EFFECTIVE FIRST DAY OF THE COVER MONTH UNLESS OTHERWISE NOTED | January 2007

**BOARD OF DIRECTORS' MINUTES | SPORTS CAR CLUB OF AMERICA, INC. | December 8, 2006**

**SUBJECT:** Errors, and Omissions, Competition Adjustments, Clarifications, and Classifications.

**FIGURE 1**

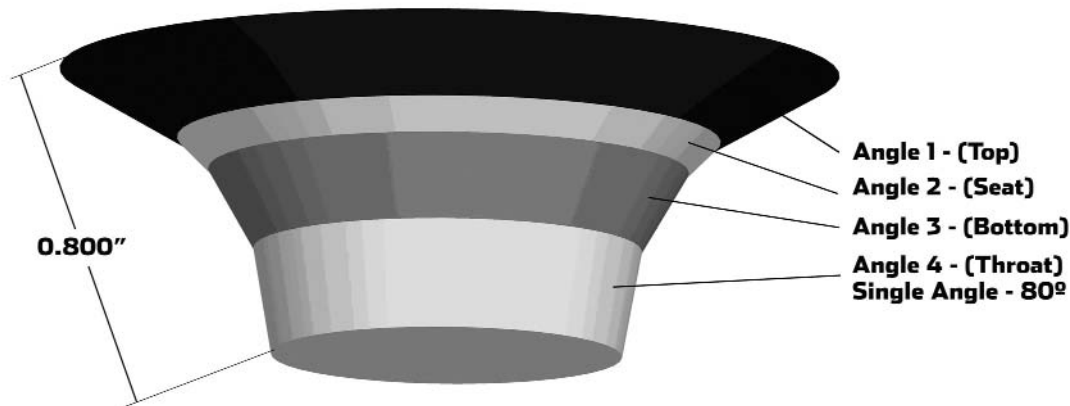
- ~~1. Direct replacement high volume/pressure oil pumps may be fitted provided that no modification to the engine is required for their installation. Alternate oil pump drive shafts may be fitted.~~

FIGURE 1

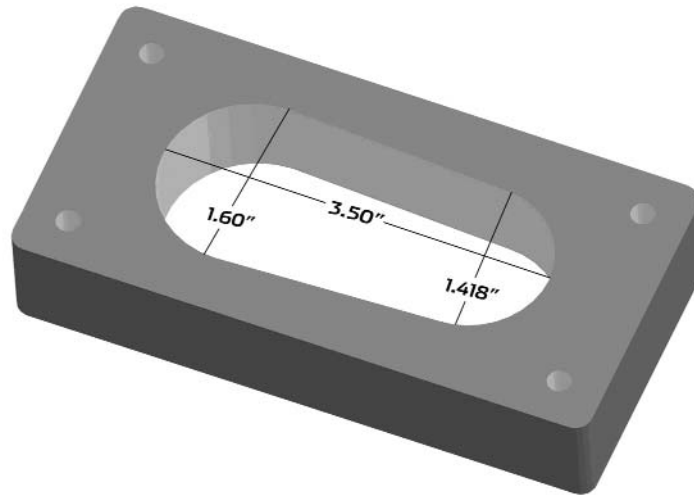
Maximum size at carburetor flange: ~~3.060" x 1.389"~~ See Figure 1

~~The diameter of the ports on the updated engine may exceed the above listed dimensions if the casting bore is untouched and in its original state.~~
